ADDENDUM NO. 03

Northland Corridor Redevelopment Project Phase 4
631 Northland Ave.
Buffalo, NY 14211

Project No. 432607

Project Northland Corridor Redevelopment Phase 4 (BUDC) Addendum No. 3
631 Northland Avenue, Buffalo, NY Contract -
Wendel Project No. 432607 Date 10/22/25

C302

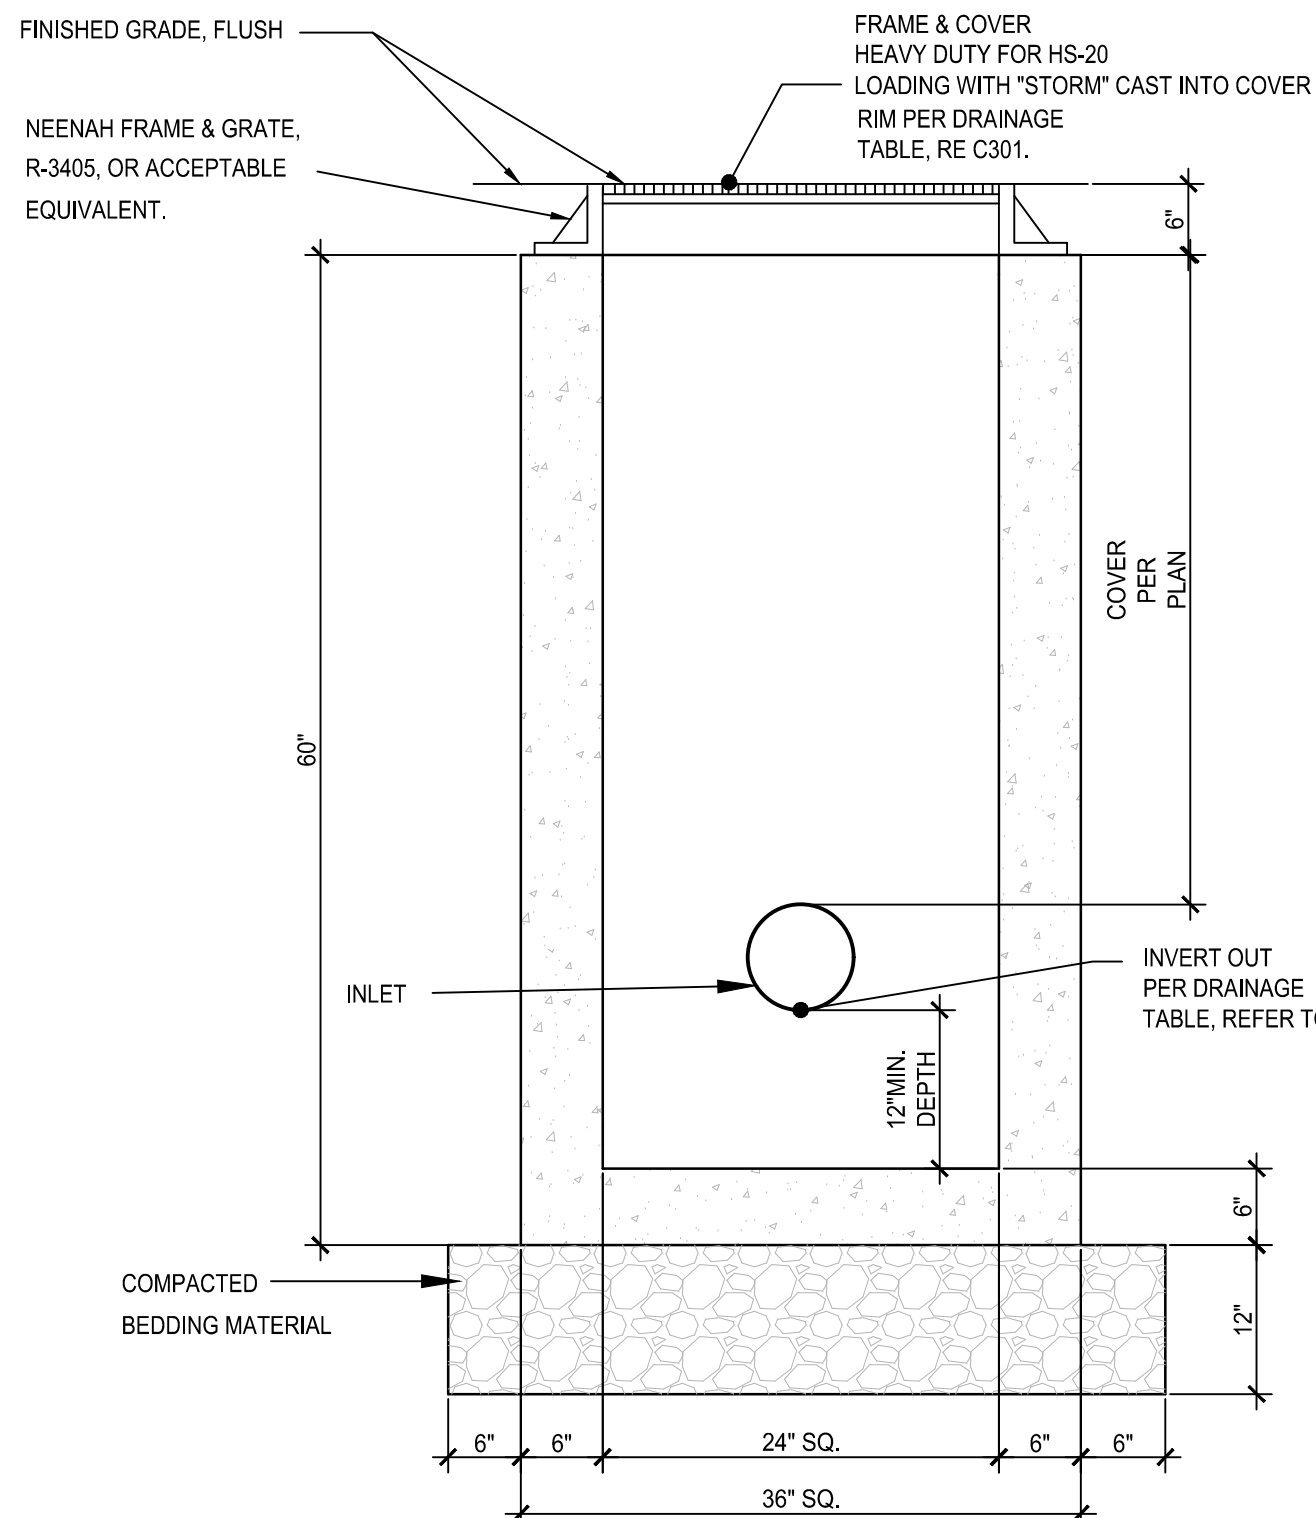
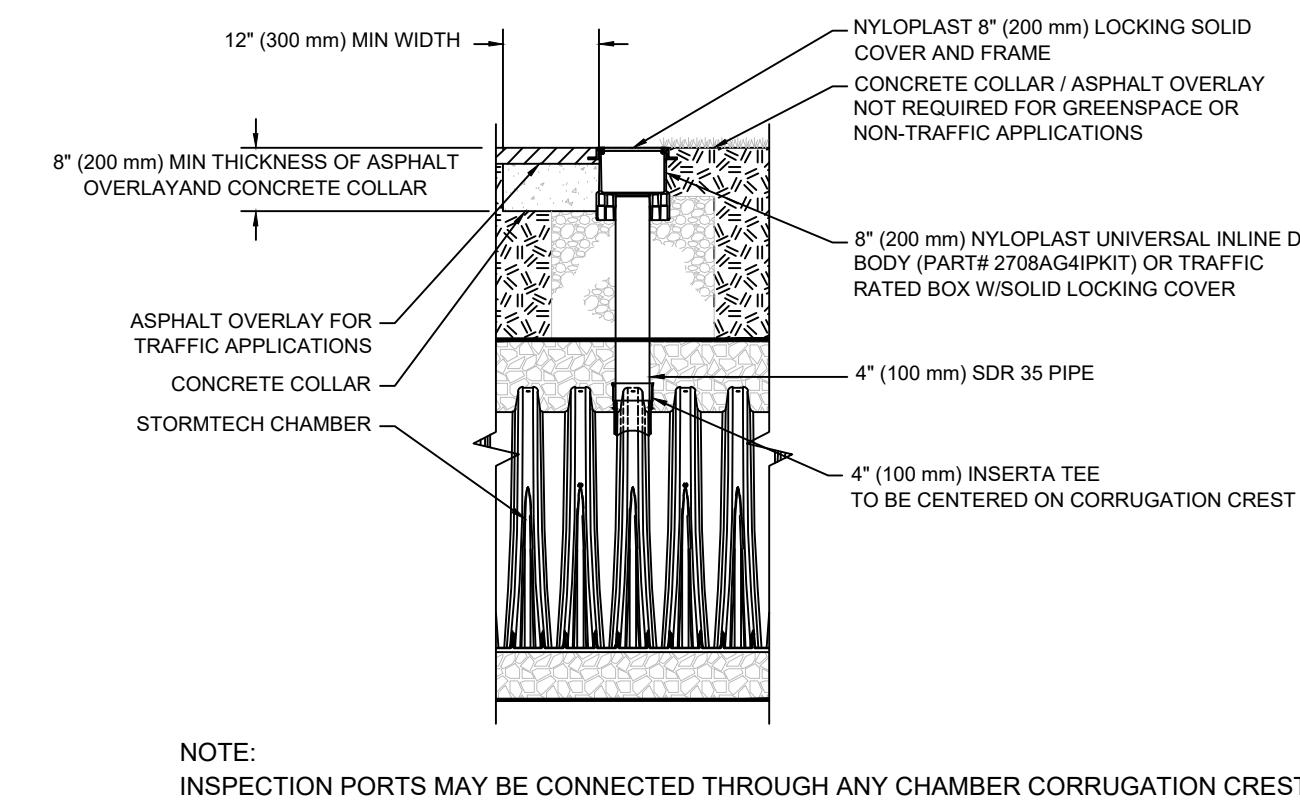
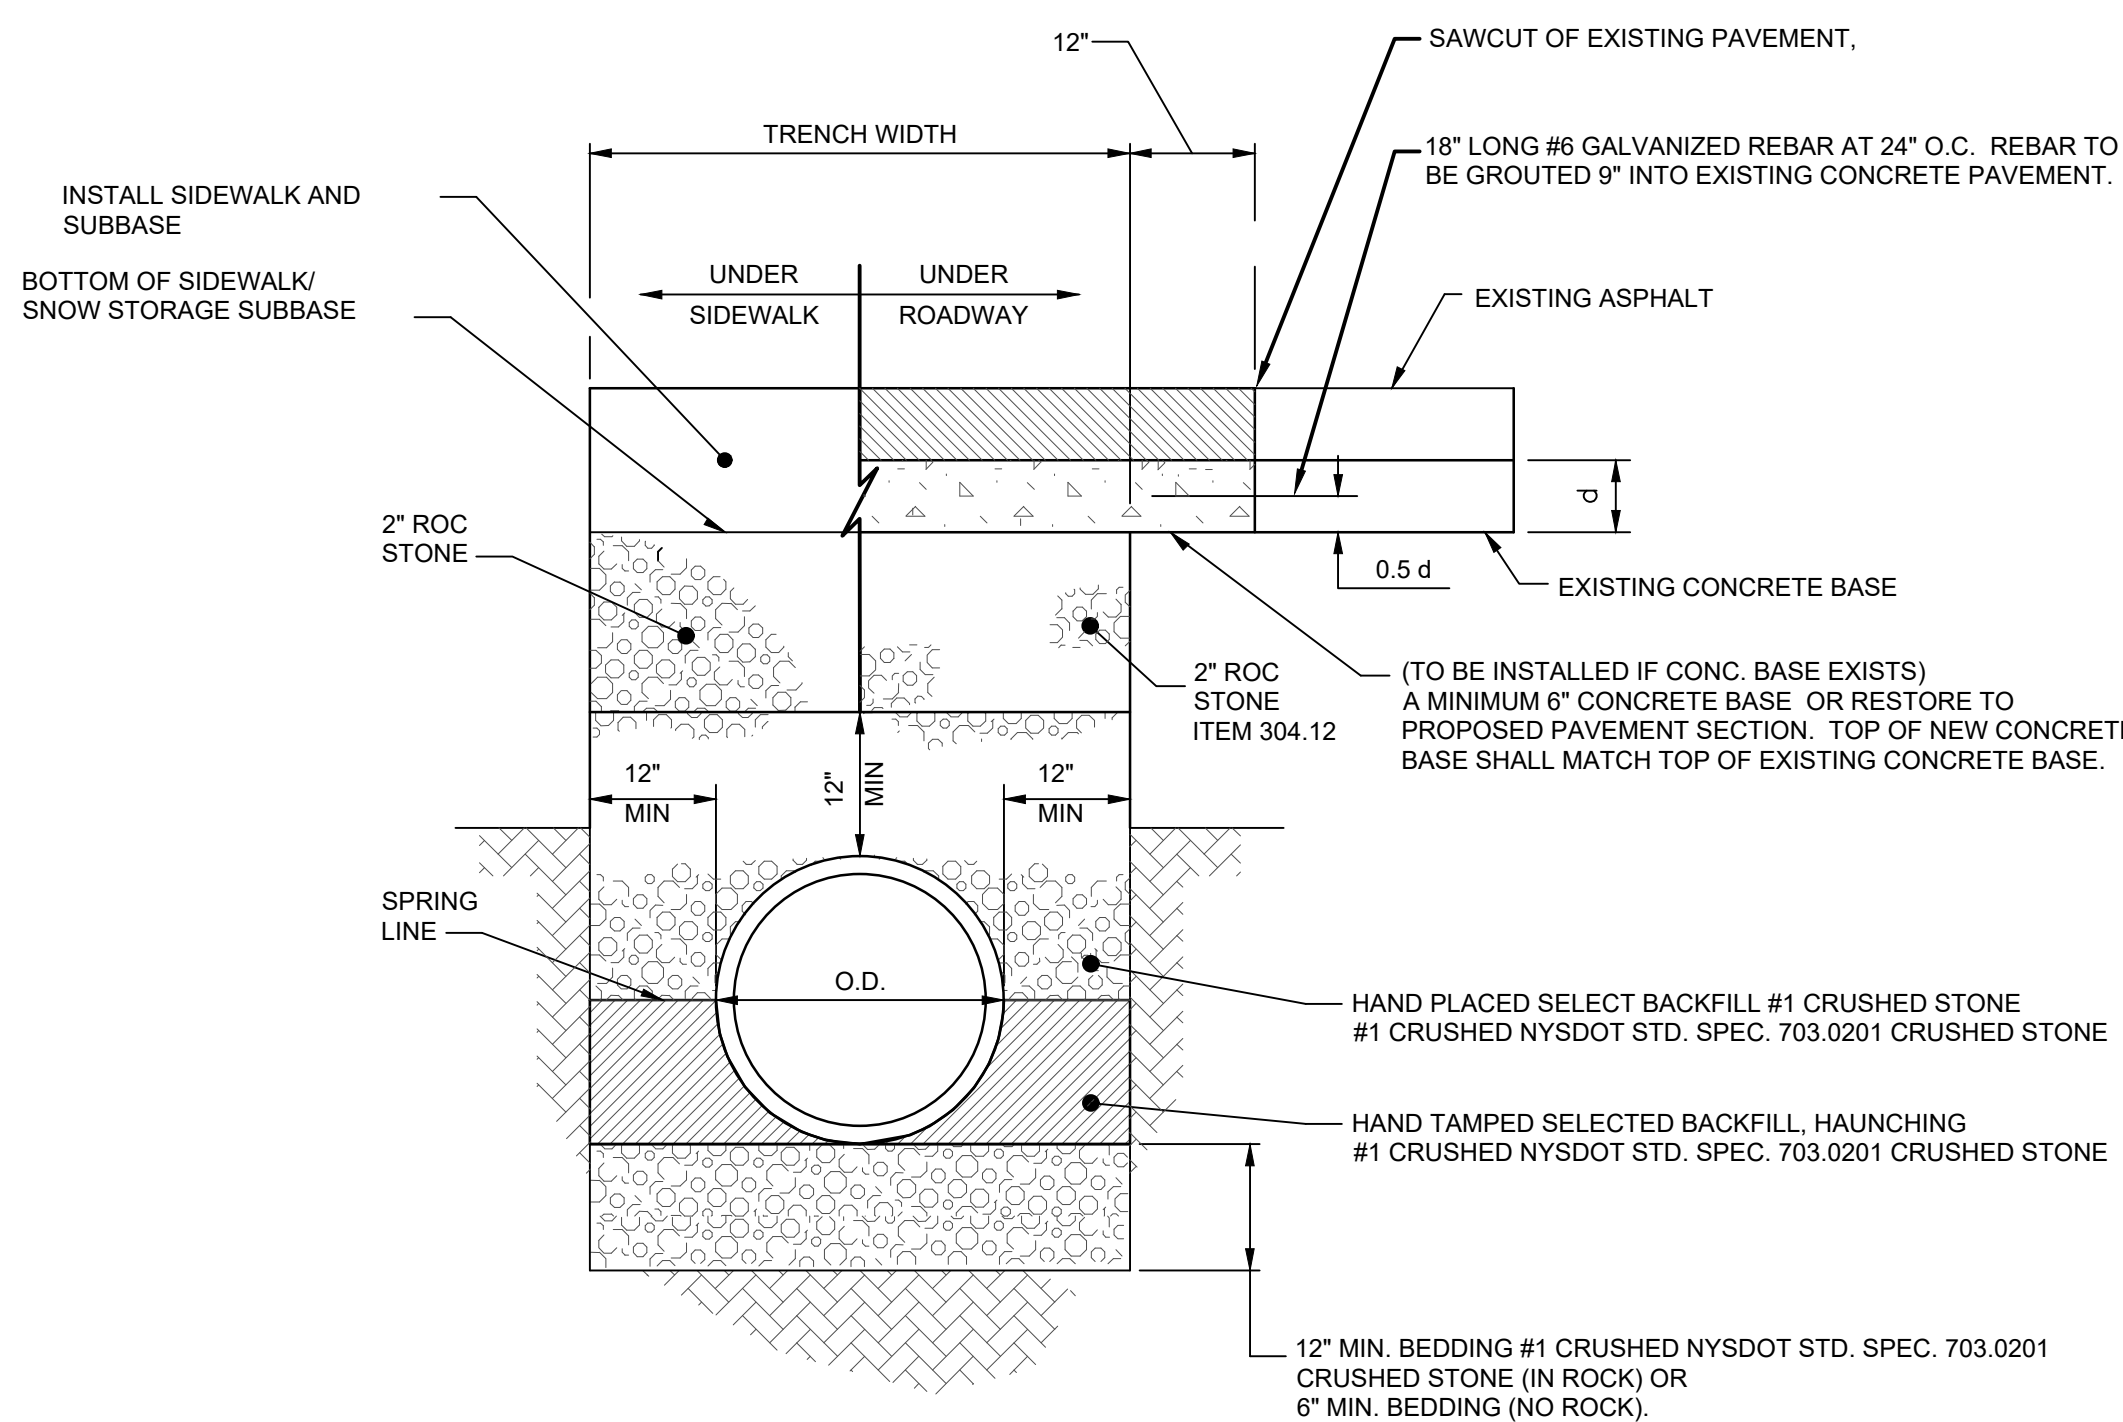
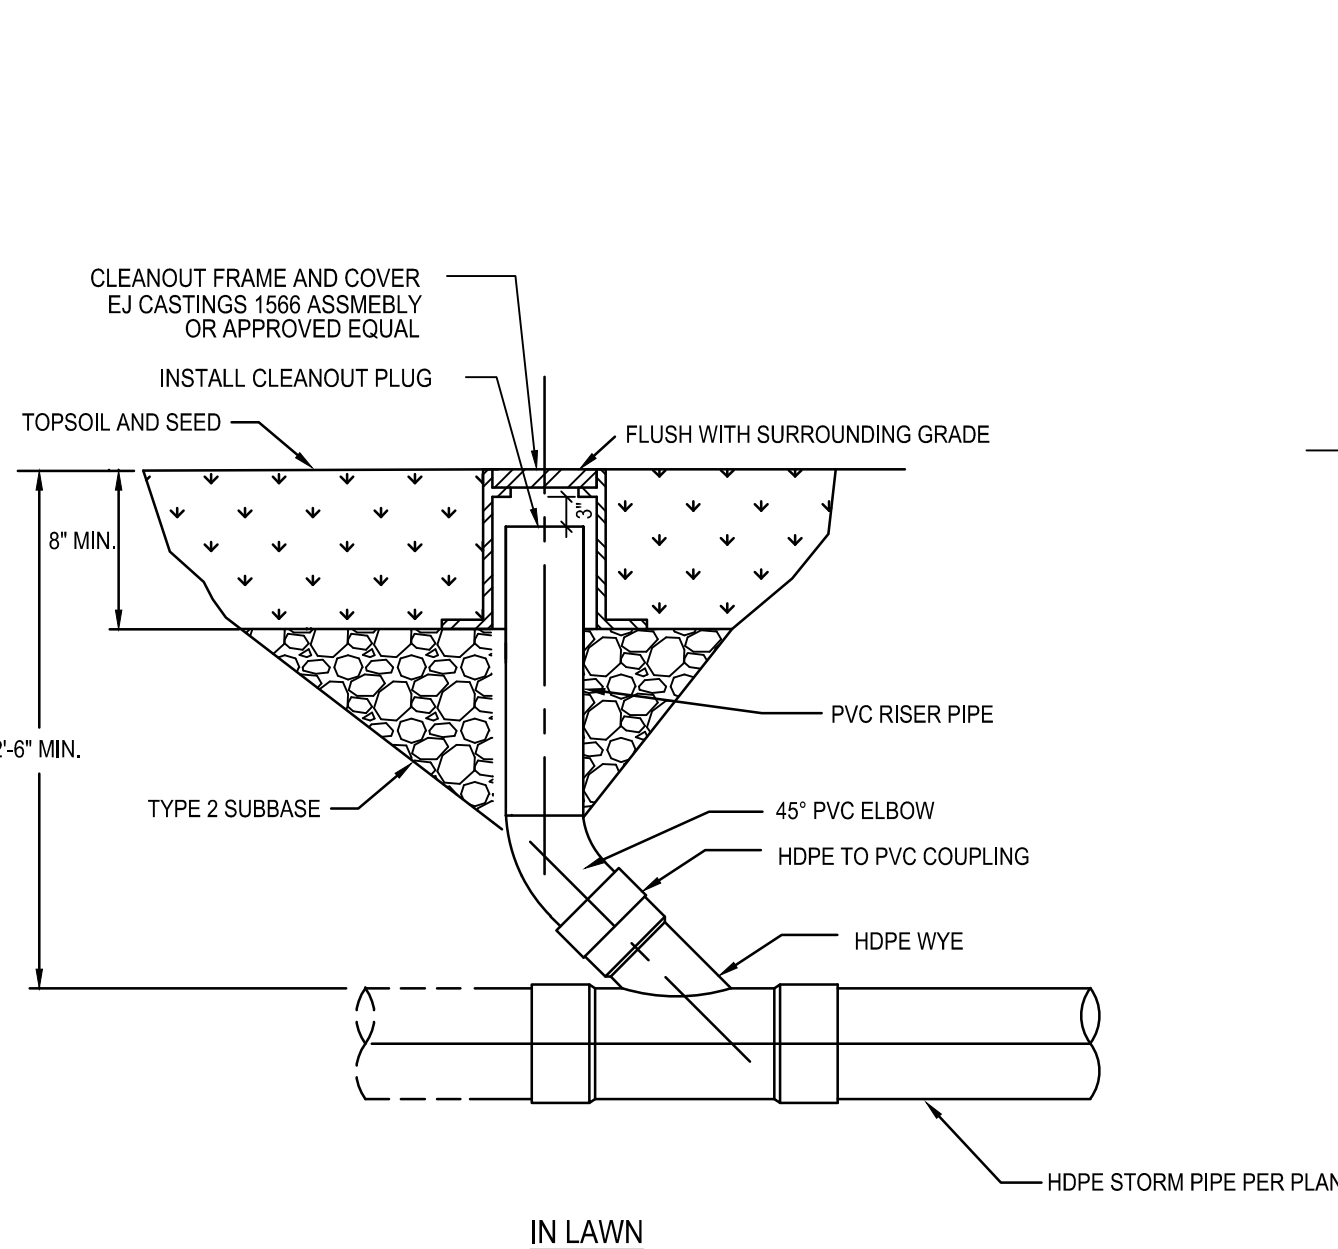
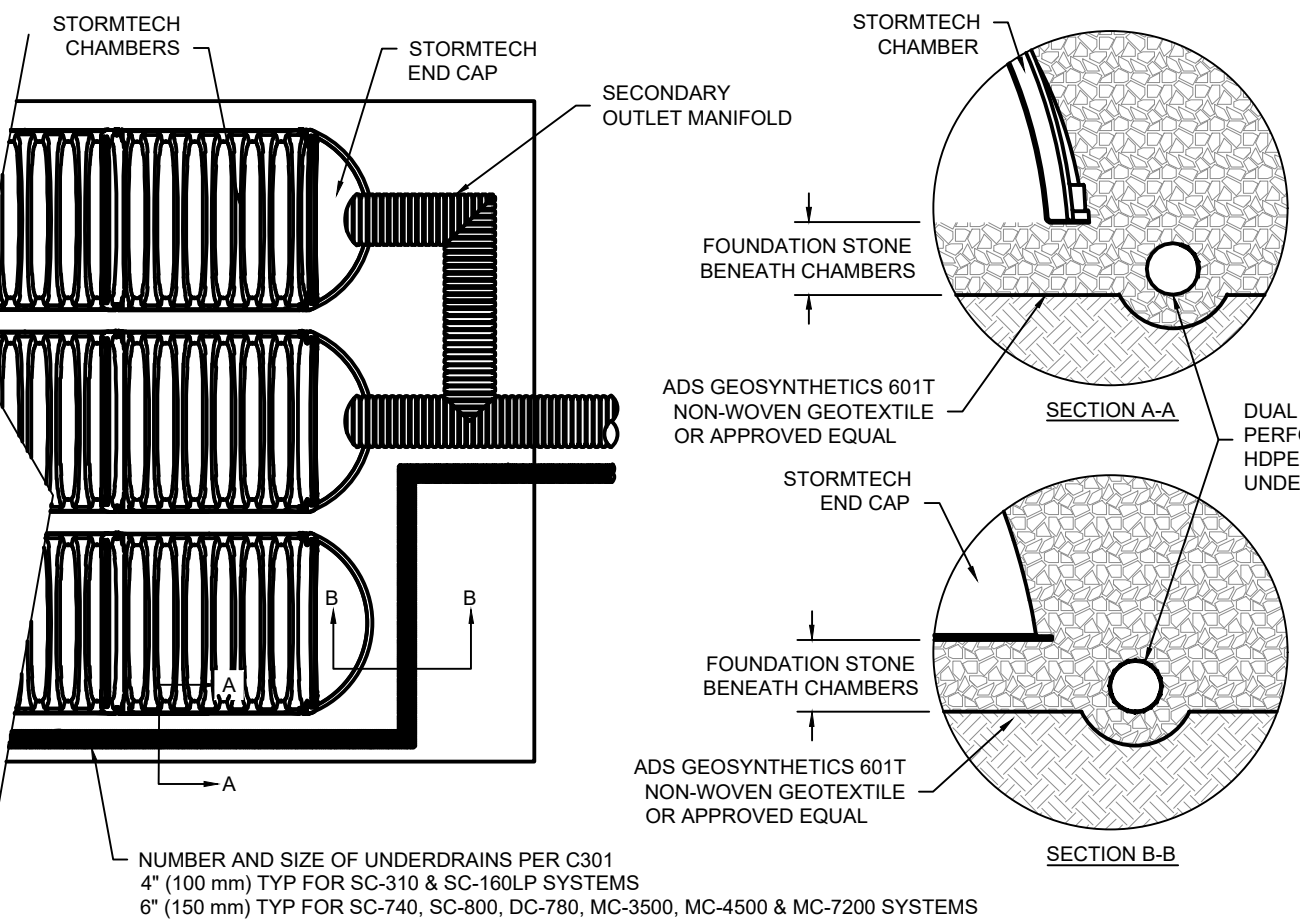
DELETE: Civil drawings C102, C103, C201, C301, C302, C503, C504.

CLARIFICATION: Revisions in the above referenced sheets accommodate environmental requirements and provide clarification to utilities, drainage, and grading.

ADD: Revised civil drawings C102, C103, C201, C301, C302, C503, C504 issued as part of this addendum.
